**Proposed Xayaburi Dam Project**  
**Assessment of the developer's documents on the**  
**planning, design, operations and management of**  
**the navigation locks**

Prepared for the  
**Mekong River Commission Secretariat**

By  
**Compagnie Nationale du Rhône**

Figure 1: typical operation curve (upstream of dam)

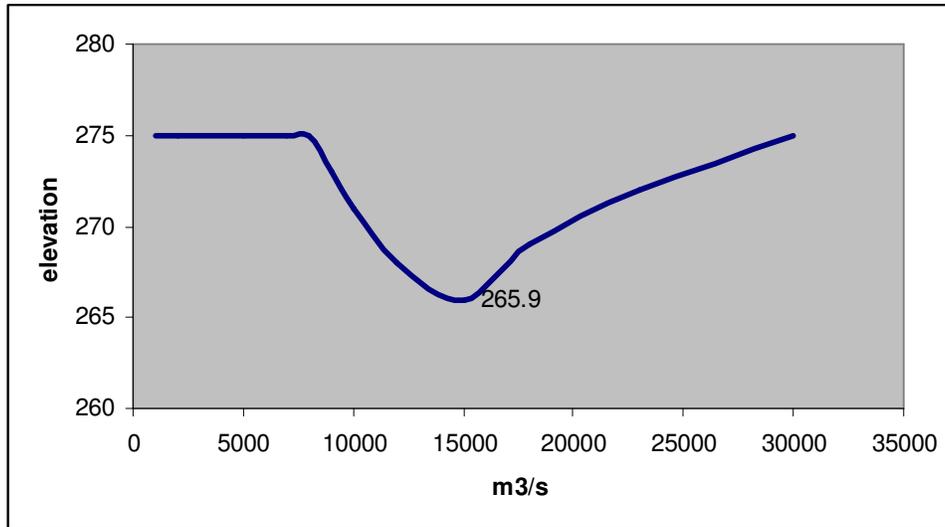
With the 15,000 m<sup>3</sup>/s flood the headwater level at the dam is to be lowered to el 265.9 m and the spillway gates would be opened fully. It suggests that the lowering of the headwater level at the dam would begin with a flow lower than the maximum navigation flow (proposed to be fixed at 12,000 m<sup>3</sup>/s to 14,580 m<sup>3</sup>/s), as represented on Figure 1 .

This disposition would induce decreasing hydraulic sections and increasing velocity values at the entrance of the spillway and the lock, in the range of navigation operations. These adverse conditions should be evaluated.

- The operation curve, giving the water levels upstream of the lock corresponding to the discharges in all situations of operations of the dam, normal, during peak flows, during flood events, should be given. The Highest Operational Level should be given.

Figure 2 : scheme of the velocity field, upstream of the lock

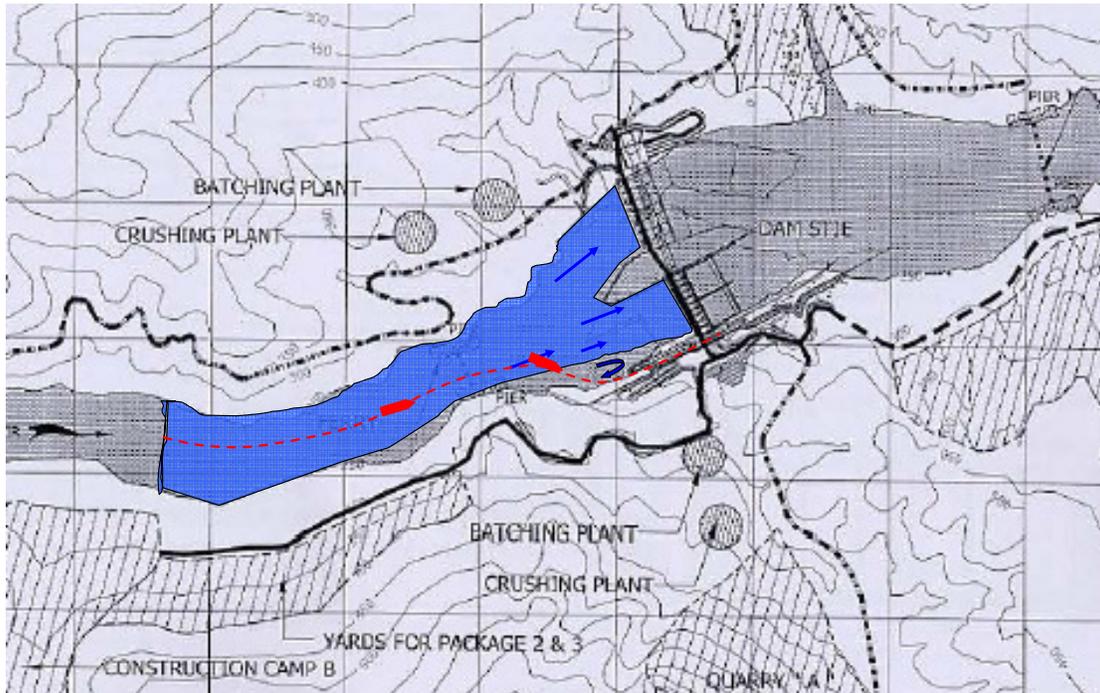
The slope of the hill on the right bank, 800 m from the dam, will undoubtedly cause a shift of the flow detrimental to the efficient distribution of the discharge in the spillway and liable to generate reverse flows in the upstream outer port of the lock, as shown on Figure 2.

With a maximum navigation discharge of 12,000 m<sup>3</sup>/s to 15,000 m<sup>3</sup>/s, the current velocity upstream of the spillway, theoretically in the region of 1m/s to 1.9 m/s on average for a perfectly homogenous supply to all the gates of the spillway, could be locally stronger (up to 2.5 m/s ?) and lead to cross currents exceeding the threshold normally admissible for navigation.

The reverse currents in the upstream outer port will also increase the risk of sedimentation and the accumulation of floating debris.

In conclusion, it is necessary to perform a more in-depth study of the navigation access upstream of the lock.

Figure 4: schematic plan view of a hydraulic feeding system with 2 lateral culverts

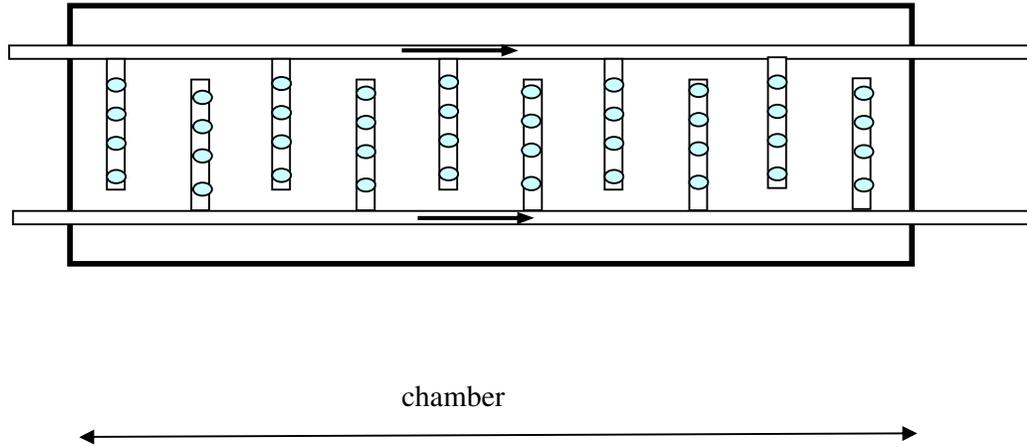
The proposed F-E system is not optimised with respect to the limitation of the lane outage since there is no redundancy of the critical equipment such as culvert gates.

Since the system is equipped with only one lateral, culvert, the same conclusion can be drawn if something occurs in the lateral culvert. A two lateral culverts F-E system would be better.

- Considering the high head of the locks and the necessity to limit the emptying and filling time, the proposed emptying and filling system is not the more appropriate one. Feeding and emptying flows vary all along the longitudinal culvert and then on the different ports on each transverse culvert. The injection of flows is therefore asymmetric, longitudinally and transversally, leading the ships to move erratically in the chambers. There is no redundancy of critical equipment (gates, culverts). A system with two longitudinal culverts and several transverse culverts in staggered rows, such as that represented in Figure 4 is recommended.
